Staff Report for the July 9, 2003, Development Review Committee Meeting

Site Plan 75-03. James City County Fire Station #2
Staff Report for the July 9, 2003, Development Review Committee Meeting

**Agency Review Comments
For
SP-75-03 James City County Fire Station #2**

ENVIRONMENTAL DIVISION REVIEW COMMENTS

PLAT SHOWING
 OF
 SHEPPARD ESTATES
 IN
 JAMES CITY COUNTY, VIRGINIA

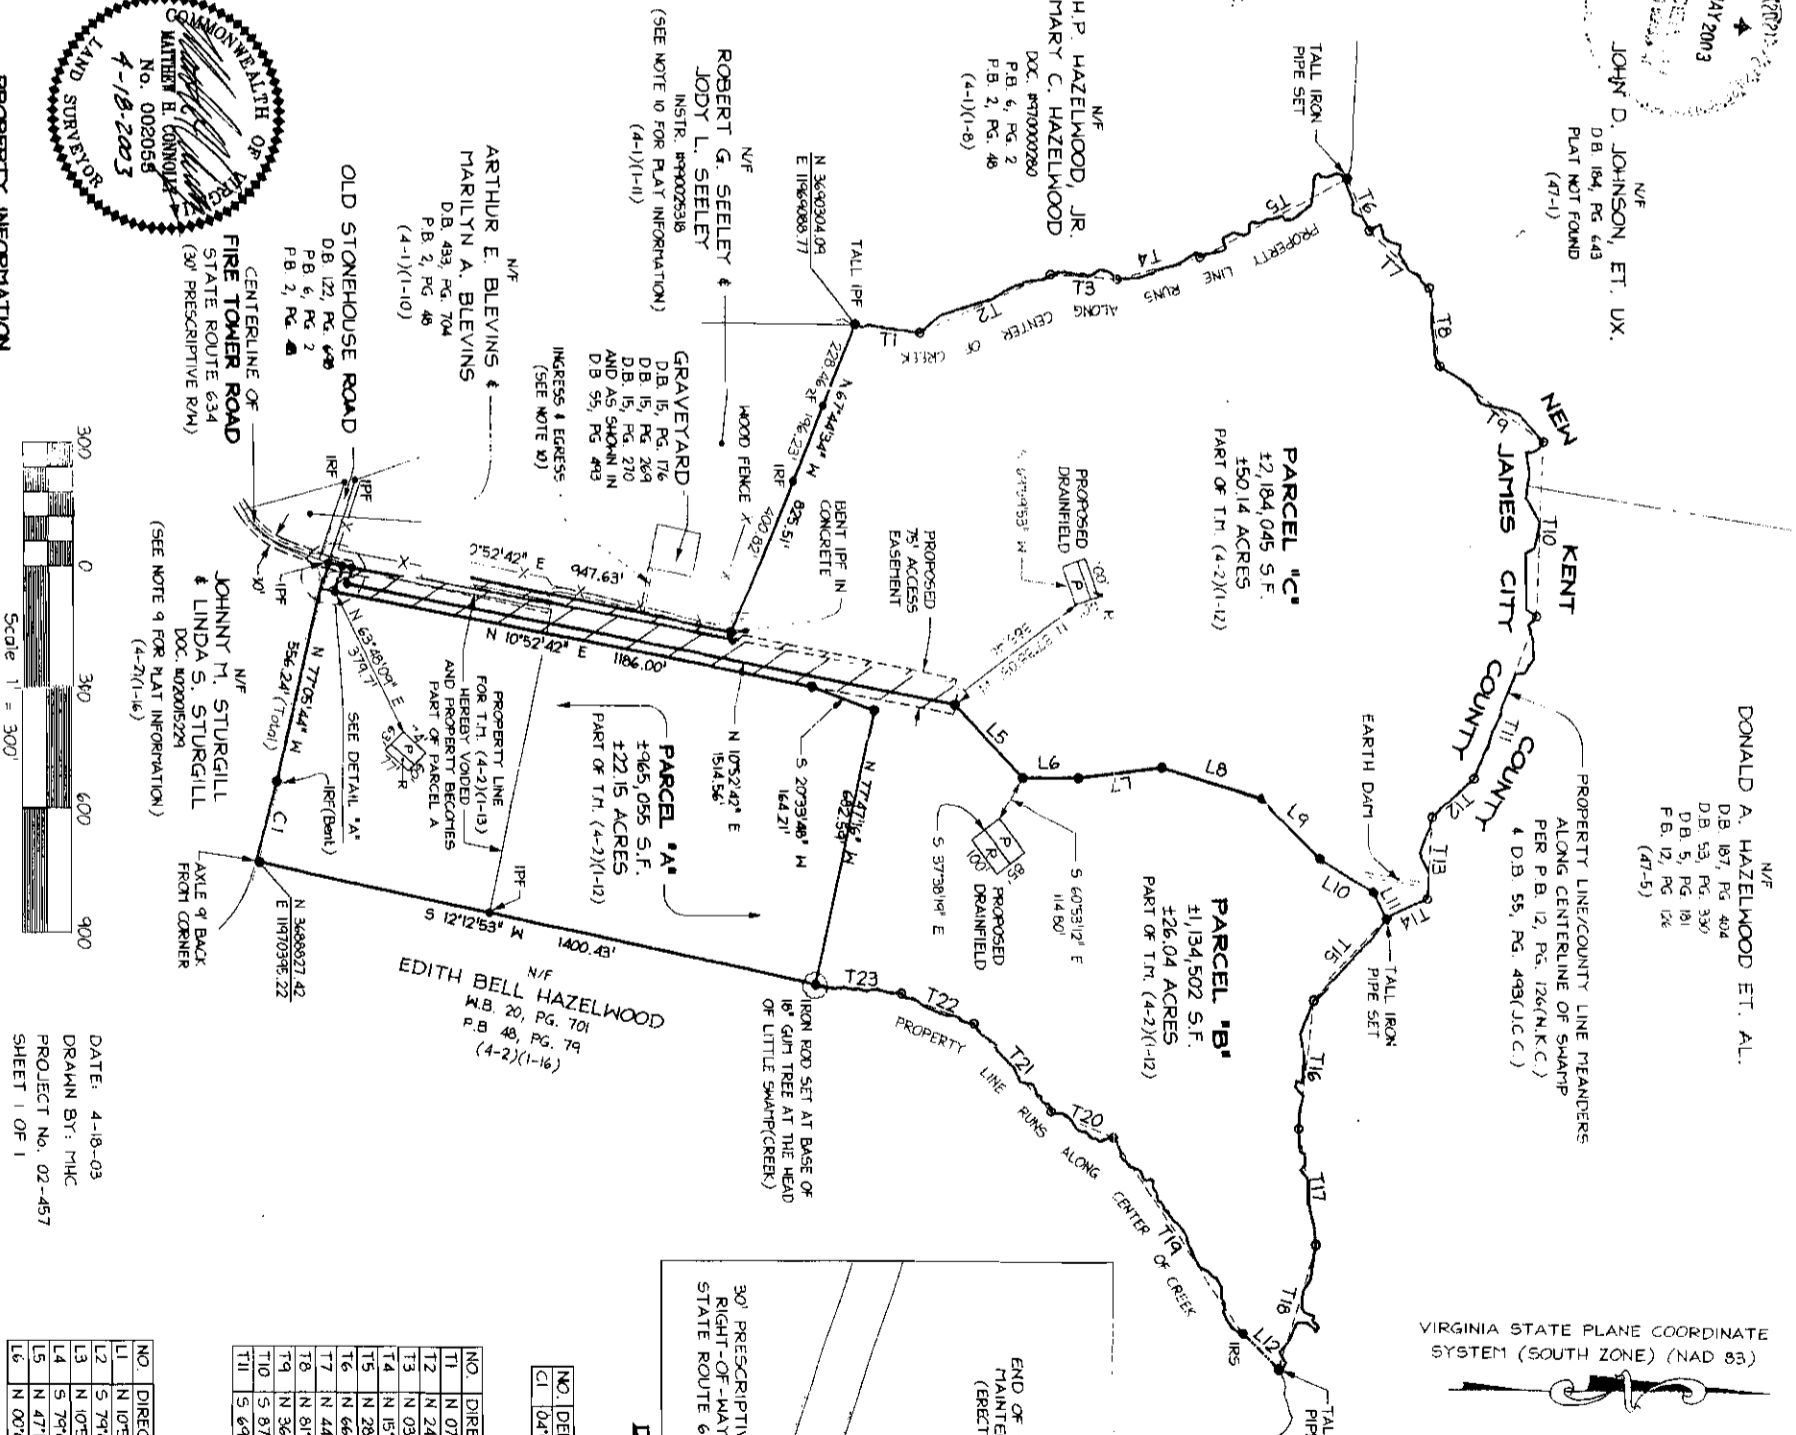
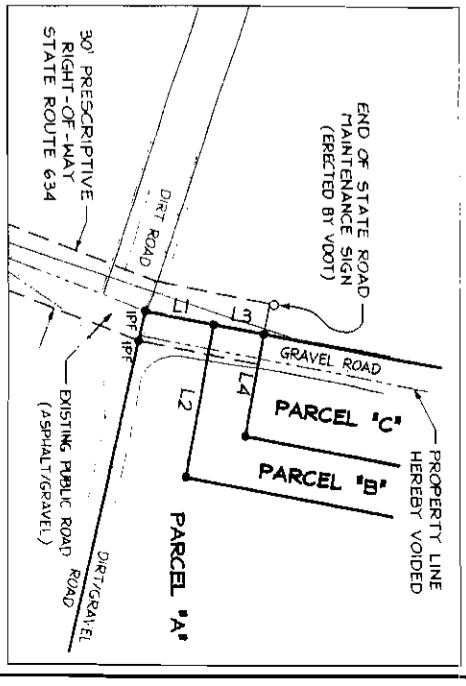
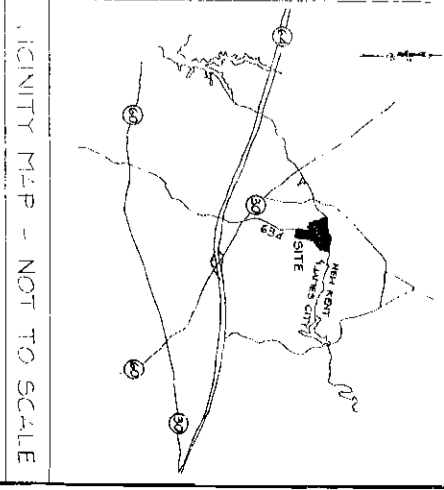
The Subdivision Ordinance requires lots outside the Primary Service Area to be served with a conventional septic system (i.e., a hold tank and drainfield). In the attached June 24th letter, the Sheppard's have requested an exception so that alternate septic tank systems can be installed for the reserve fields on the new proposed Parcels A & C, as shown on the attached subdivision plat submitted on May 21st.

Staff does not recommend approval of the request considering that a revised plat has been submitted, that if approved by the Health Department could be approved by the County without an exception to the subdivision ordinance being granted; and all of the following subdivision ordinance exception criteria have not been met:

- a.) Staff believes strict adherence to the ordinance will not cause substantial injustice or hardship;
- b.) The use of these alternative systems would not be detrimental to the public safety, health, or welfare and will not adversely affect the property of others;
- c.) The facts upon which the request is based are not unique to these properties and are applicable generally to other property;
- d.) No objection to the proposal has been submitted from the transportation department, health department; and the fire department.
- e.) No substantial hardship or injustice is created by the unusual character of the property. The applicant has submitted a revised subdivision plat proposing the use of conventional septic tank systems. Financial hardship resulting from the applicant not being able to plat and sell these three lots is not considered proper justification for an exception.
